TO: Buck Oven
 FROM: Clair Fancy 
 DATE: February 25, 1993
 SUBJ: OUC's Stanton #2: Concrete Batch Plant Evaluation for a PPS Certification Modification Request

Re: Orlando Utilities Commission's Proposed
Modification of Site Certification to
Authorize Construction of a Temporary Concrete
Batch Plant; Curtis H. Stanton Power Plant,
Unit No. 1 - PA-81-14

Re: Orlando Utilities Commission Request for Modification of
Conditions Of Certification for Stanton Energy Center

PROPOSED AGREEMENT FOR
MODIFICATION OF CERTIFICATION

FIGURE 3.3.3.1

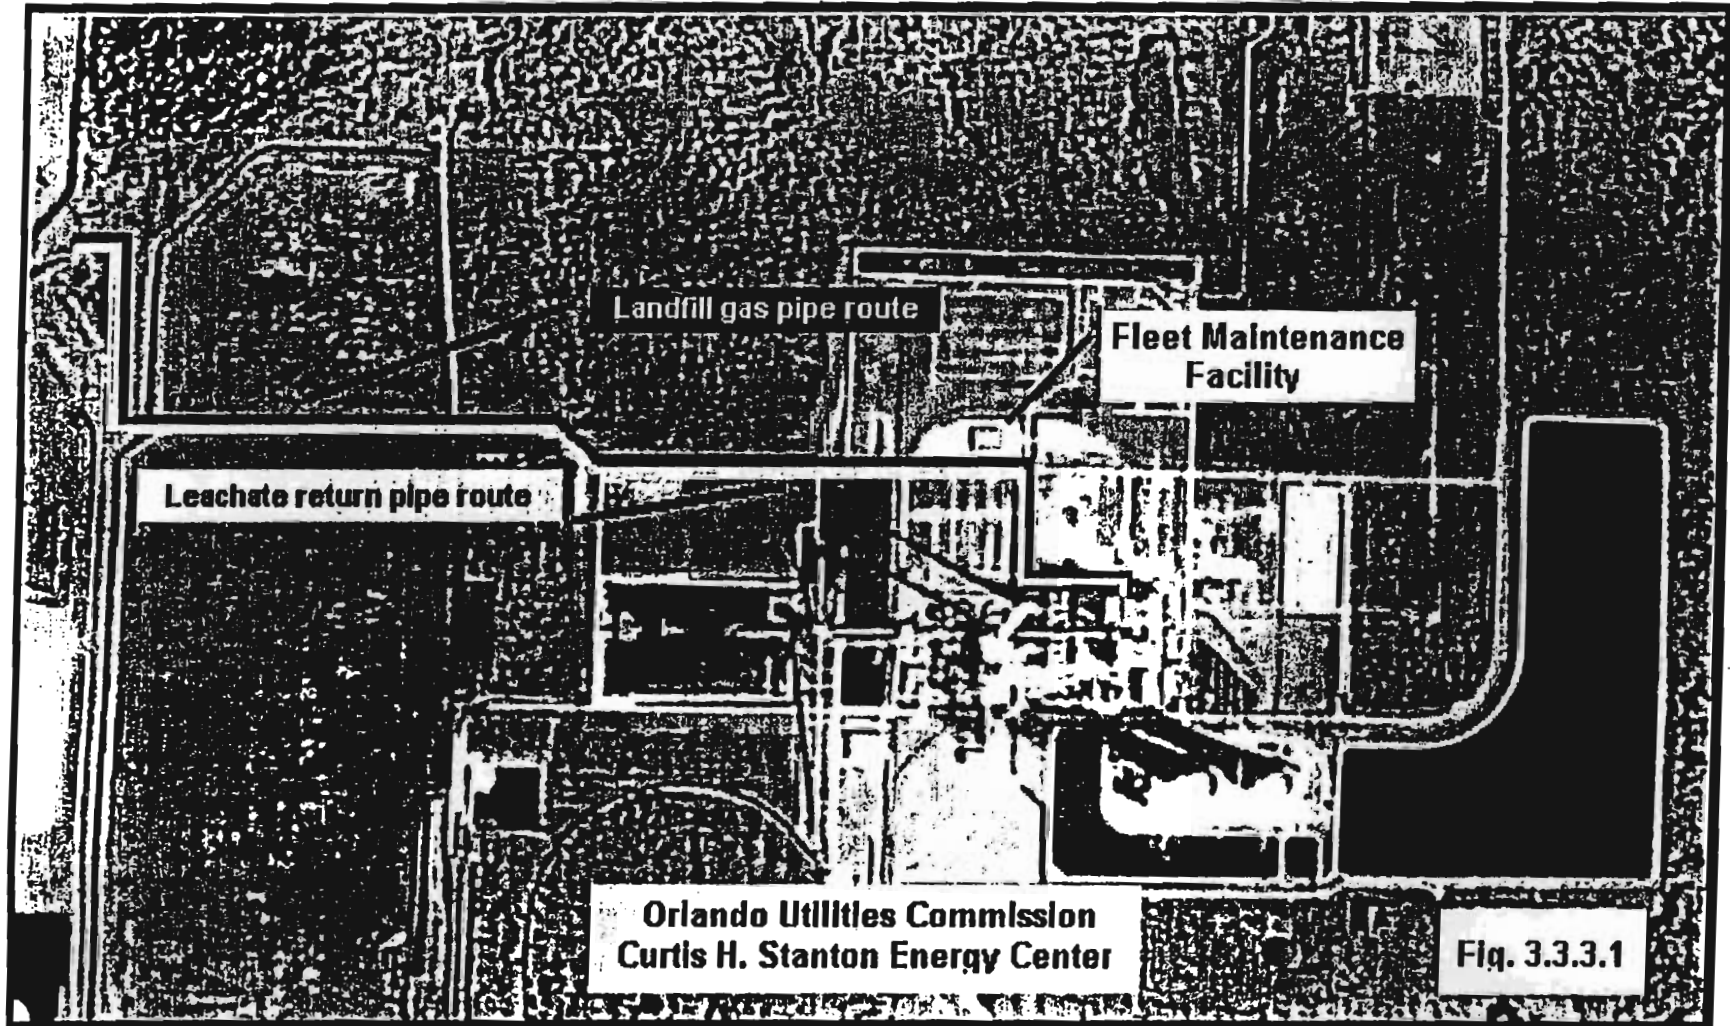
Landfill gas will be delivered to the Stanton Energy Center via a pipeline from the Orange County Landfill. Figure 3.3.3.1 shows the route of the pipeline which parallels the existing roadway on land already impacted by previous construction activities.

VFL TECHNOLOGY CORPORATION
NEW LIME SILO SYSTEM P & ID	
7/11/97

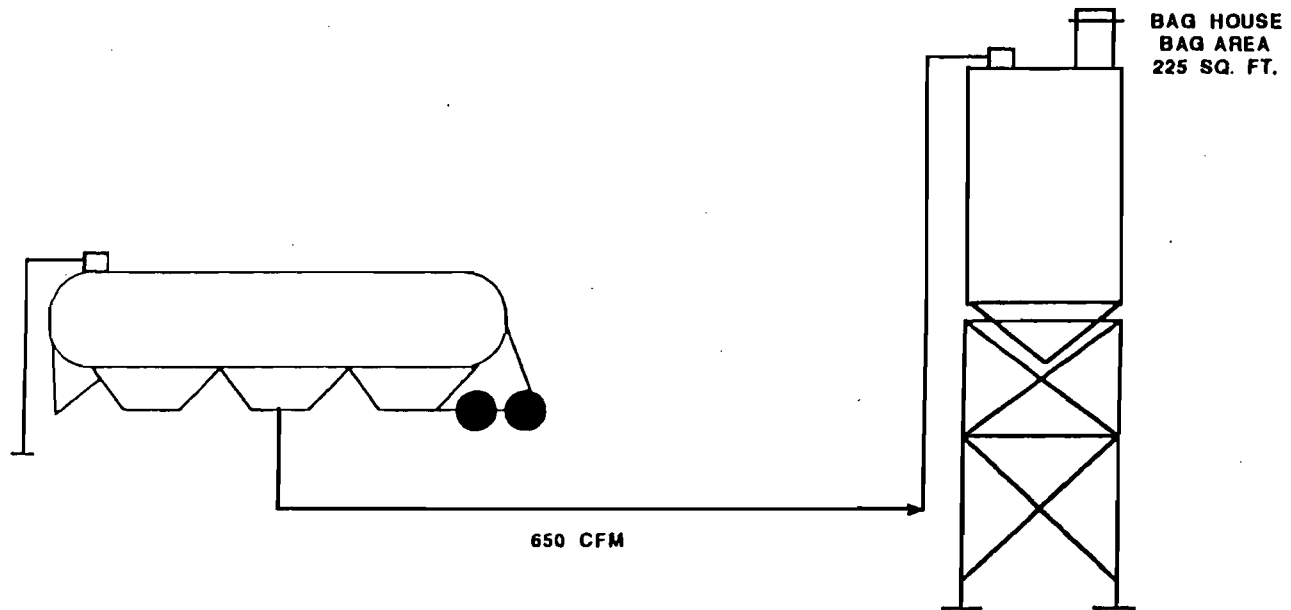
~~Pebble lime will be used as an additive to condition the scrubber sludge. The lime will be received by truck or by railcar dumping into an enclosed receiving hopper. A rail/truck unloading facility is served by the plant maintenance rail spur near the Coal Crusher Building as shown on Figure 3.1-4. The lime will be transported from the hopper to a storage silo by a pressurized pneumatic system. The silo will vent through a fabric bag filter system with a removal efficiency of at least 99 per cent. From the storage silo, the lime will be conveyed to a pulverizer and then to the sludge/ flyash mixers.~~

A new lime silo system will be constructed to serve as a standby or supplemental lime source in the event additional lime is required in the scrubber sludge fixating process. The existing lime silo as described in the original SCA will be modified to transport and store the flyash recycled from fluidized bed Units located off site. This fluidized bed ash is now the primary material used to stabilize the bottom ash and scrubber solids generated at the Stanton Energy Center. Since the lime will not be required on a regular basis, the capacity of the new silo will be reduced to 50(+/-) Tons. Silo operation will be similar to the existing lime silo operation where pneumatic trucks load the silo and silo discharge will be through screw conveyors to the mixers. The trucks will unload the lime with 650 (+/-) CFM of air to the silo where it will pass across a bag house with 225 (+/-) Sq Ft. of bag area. The Cloth to CFM ratio for the lime system is 5.25 to 1.0. See drawing "NEW LIME SILO SYSTEM" attached.
